Interactive comment on “Slope stability and rock fall hazard assessment of volcanic tuffs using RPAS and TLS with 2D FEM slope modelling” by Ákos Török et al.

Answers to the review of interactive comment on “Slope stability and rock fall hazard assessment of volcanic tuffs using RPAS and TLS with 2D FEM slope modelling” by Ákos Török et al. Anonymous Referee #2 Received and published: 15 April 2017
Reply: 10 June 2017

Fig. 1. New Figure, Fig. 14 Location of some studied cross sections

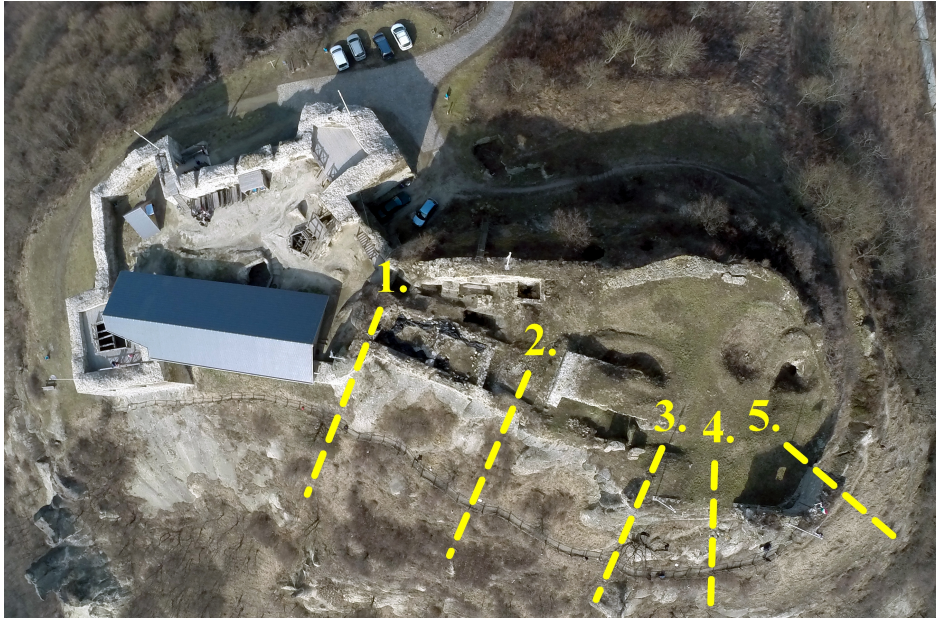
12) Consider to delete figures 2, 11, 12, 13, and 21. In my opinion they do not add particular value to the analysis. It is not clear which parts of the slope is shown in figures 9, 10, and 14. Please add a specific map. Indicate also the localization of the cross sections of figure 22. From the text, is not clear the number of tested sections and the width of the slope.

Answer: Fig. 2, Fig. 11, Fig. 12, Fig. 13 and Fig. 21 were deleted from the text. A new Figure was added to show which parts of the slope are shown in new Figures. An additional Figure describes the location of cross sections was added to make it more clear. Out of 55 tested cross-sections 5 were chosen to analyze the global stability. Figure 22 shows two examples for the results of the analyses: Section 1 and 3 (see new Fig). Local stability analyses were not constrained to specified sections. Areas of the possible failures were determined with kinematic analyses.

Fig. 2. New Figure: Fig. 12. Joint system obtained by RPAS (marked on catchment area DEM) and also measured on the field. Numbers refer to major joint systems marked on DEM map and on rose diagram

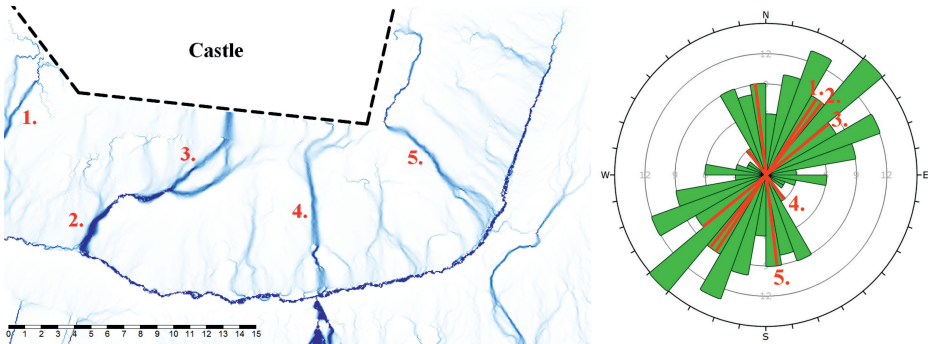
11) The number, orientation and typology of the major discontinuity systems is not stated. The graph of figure 18 is not self-explanatory.

Answer: Former Figures 18 and 19 (now new Figures) show the stereographic projection of the measured discontinuities as a lower hemisphere projection. Each point on the stereonet represents a normal vector of a discontinuity plane. Based on the

projections six main joint sets (85/156, 88/312, 79/110, 81/089, 82/064, 61/299) can be separated.

Fig. 3. The results of the global stability analysis of the slopes (sections 3 and 4 on Fig. 14), total displacements are marked in blue to red (lithology is indicated by letters A-D, note the weak zone)

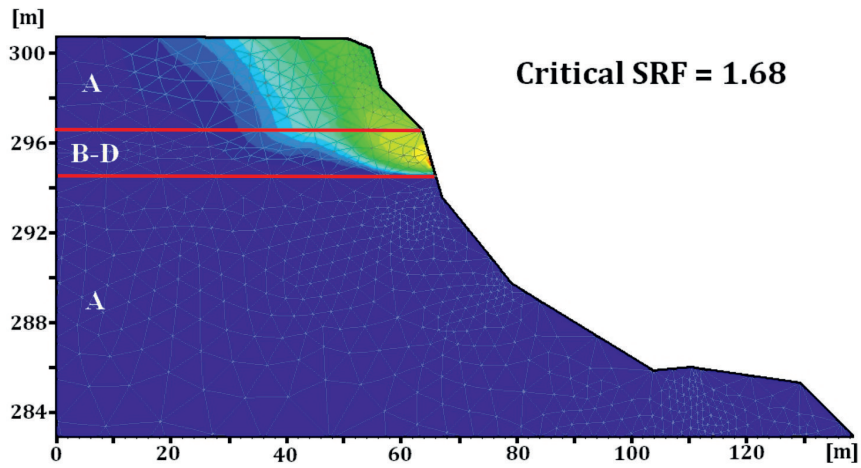
10) The result of the stability analysis is not clearly described. Even if the author state that the critical global factor of safety is above 1, they then indicate that "the failure occurs in the weak layer". . . In this way, it is not clear what the reader should conclude looking at the analysis. Probably they would state that the slope is stable in the modeled conditions but a perturbation might induce its failure with the formation of a slip surface that should nucleate from the weaker layer. Please clarify this aspect. Additionally, from the text it is not clear if the authors account for discontinuities in the global stability analysis.

Answer: The slope stability analysis was modified in the revised paper. A modified figure that shows the "weak layers" in the slope stability model was added to the revised manuscript, clearly marking the calculated slip surface at the weak layers. A new figure that describes the studied sections is now part of the revised manuscript. The difference between this model and the planar failure and wedge failure were described in more details. A figure that shows the joint orientation (and DEM model) explains better these types of potential failures.
